PROJECT: LANDS OF BOURDET
PACHECO PASS HIGHWAY, APN 898-19-005
SANTA CLARA COUNTY, CALIFORNIA

SUBJECT: Review of Proposed Septic Leach Field Conditions

REF.: Site Evaluation Results Map, by BioSphere Consulting, dated 07/22/22,
Provided to Earth Systems Pacific via email July 22, 2022.

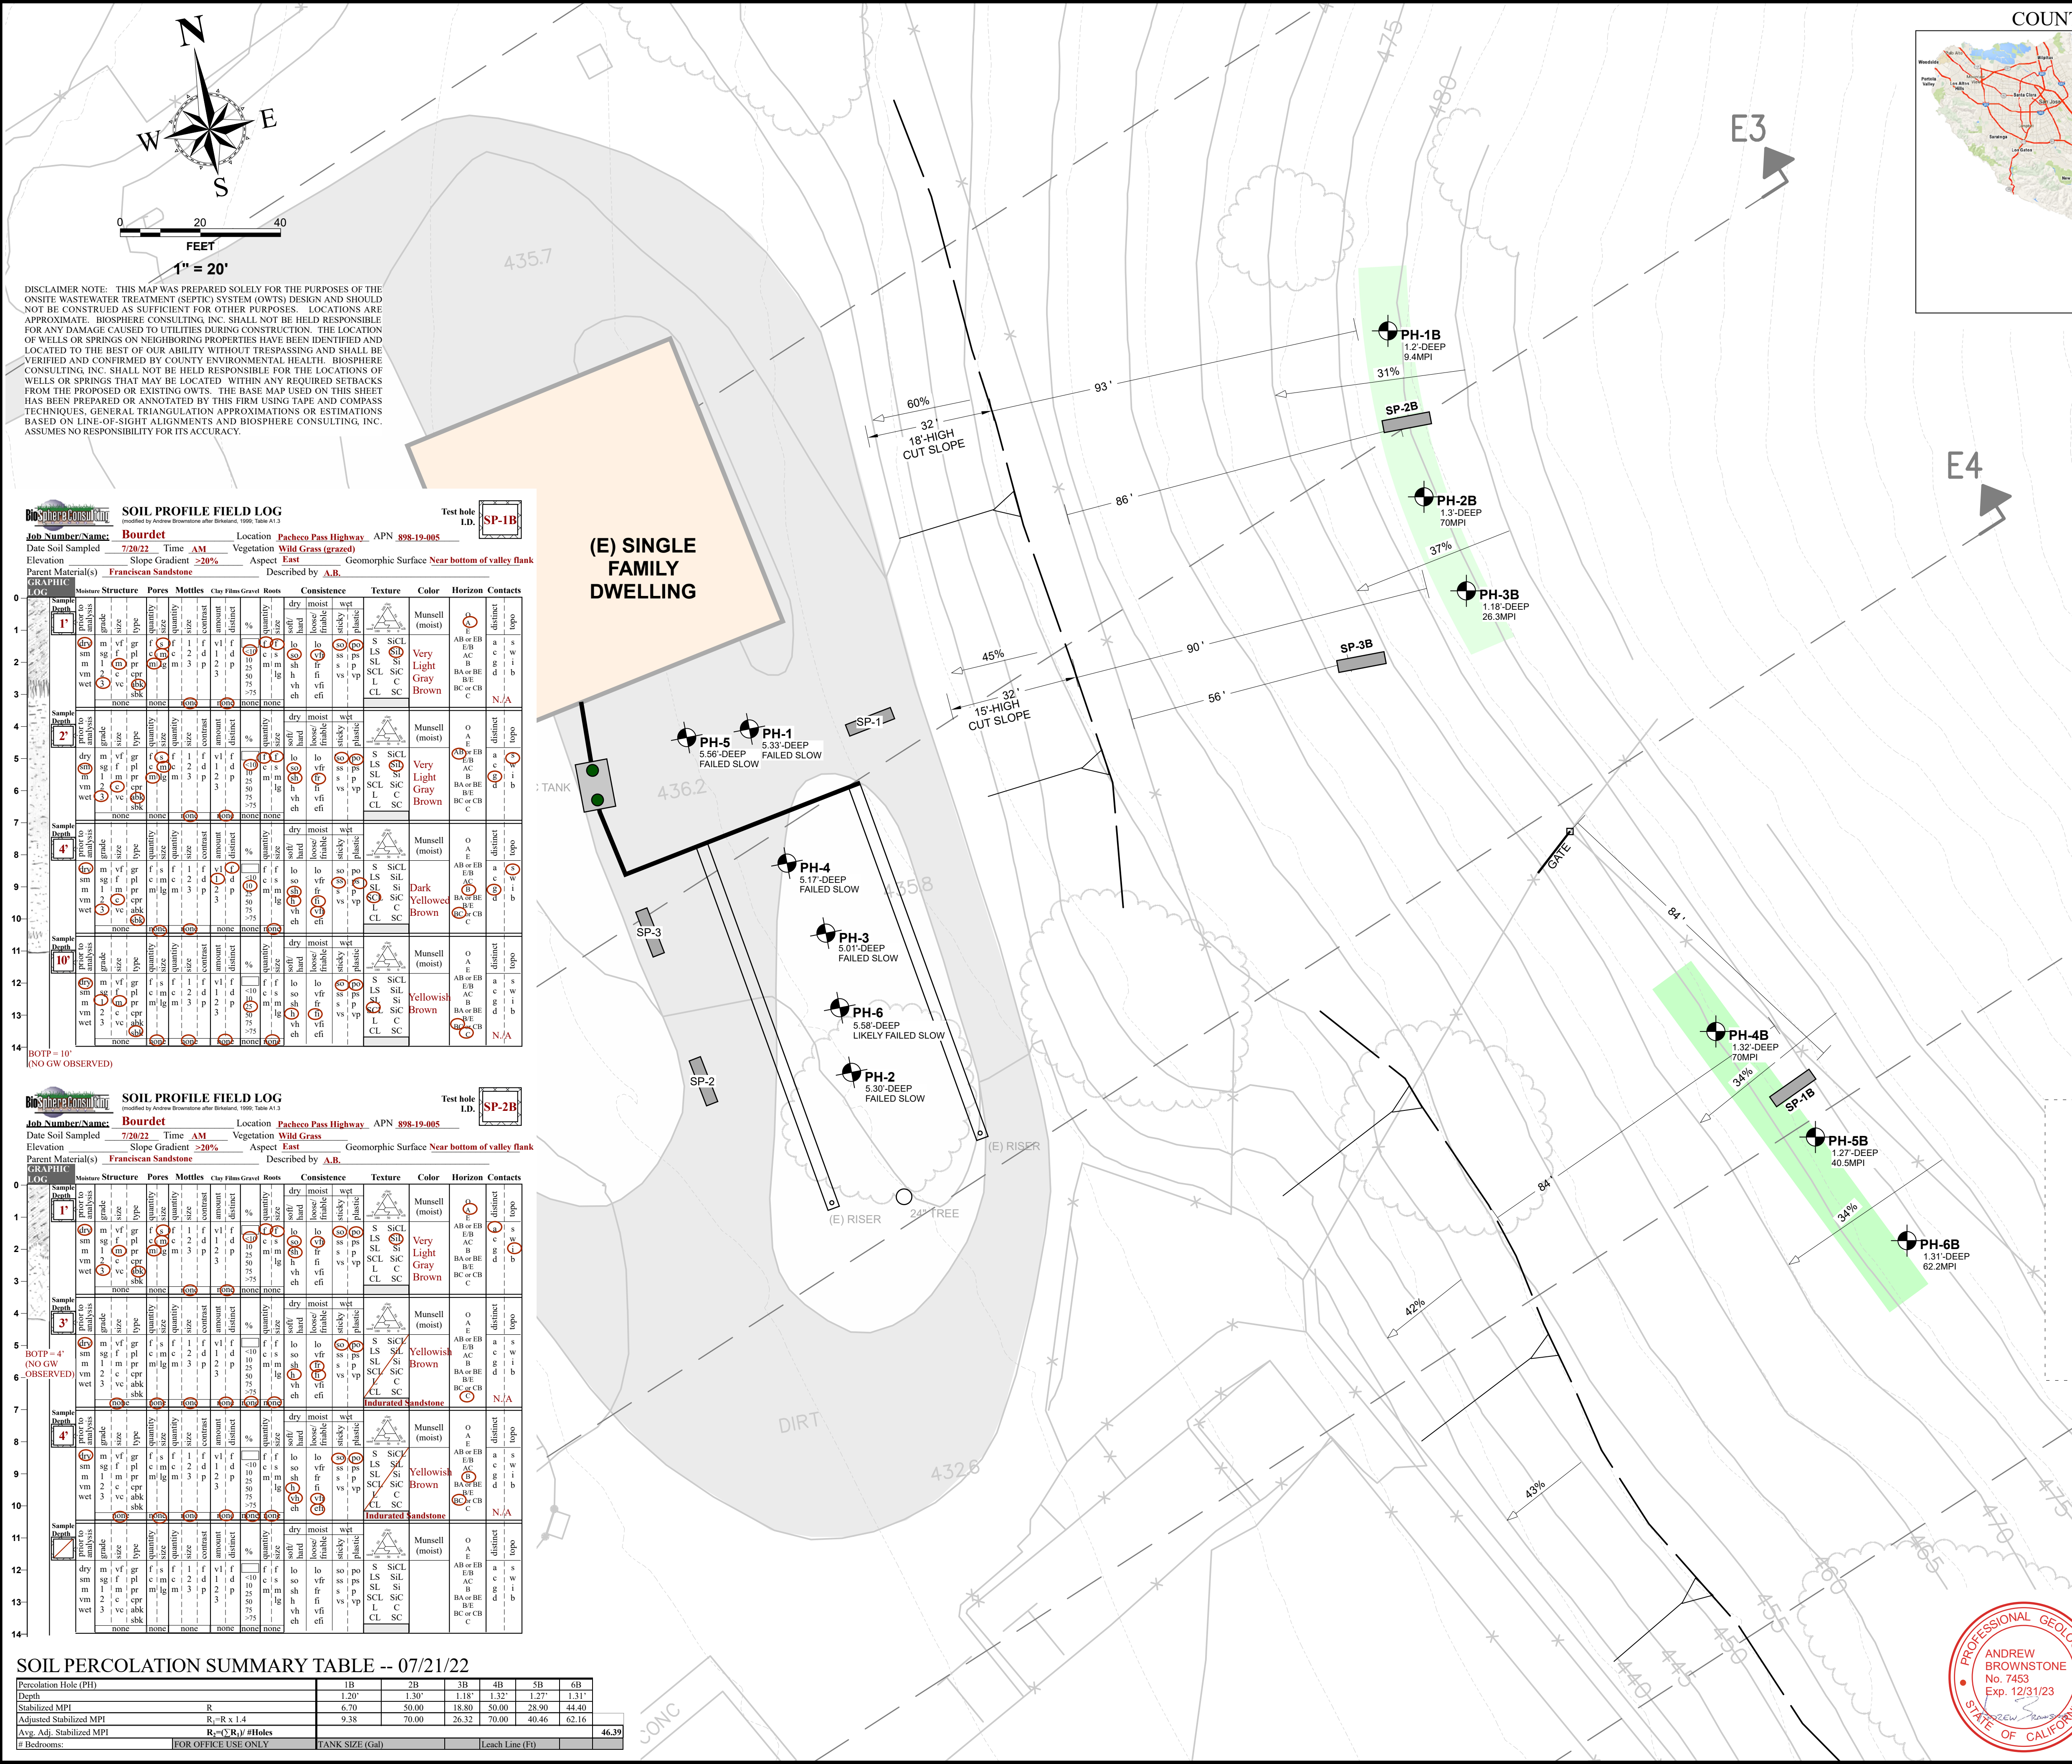
As shown on the map by BioSphere, the proposed leachfields will be located on west-facing slopes east of the existing residence in Harper Canyon. A northern and southern leachfield system are planned. Slopes are inclined between 31 and 37 percent in the area of the northern leachfield. The northern leachfield is located approximately 90 feet east of the top of a 15-18 foot-high cut slope inclined westward at 45-60 percent. The southern leachfield is located on slopes inclined approximately 34 percent to the southwest. The southern leachfield is located approximately 65 feet east of the top of a 18-20 foot-high cut slope inclined westward at approximately 42-43 percent. The cut slopes below the proposed leachfields are associated with the graded pad for the existing house and arena. We observed sandstone and shale bedrock in the lowermost sections of the cut slopes at the time of our visit on July 20, 2022. The few bedding exposures we observed dip obliquely into the slope. A small soil slump was observed in the cut beneath the oak tree downslope of the northern leachfield. No other signs of slope instability were observed in the area of the proposed leachfields.

Based on our site visit, review of the Site Evaluation Results Map by BioSphere, our understanding of the proposed septic system design, and subsurface conditions encountered in the exploratory test pits, it is our opinion that the proposed septic system is unlikely to permit effluent to surface, degrade water quality, affect soil stability, present a threat to public health or safety, or create a public nuisance. We recommend the leachfields be fenced off to prevent livestock from damaging the shallow drip system. We also recommend the leachfields be protected from precipitation runoff from areas upslope.

As noted above, the final design of the septic system was not available for our review. Once complete, Earth Systems should be provided with a copy of the design for review to confirm our conclusions.
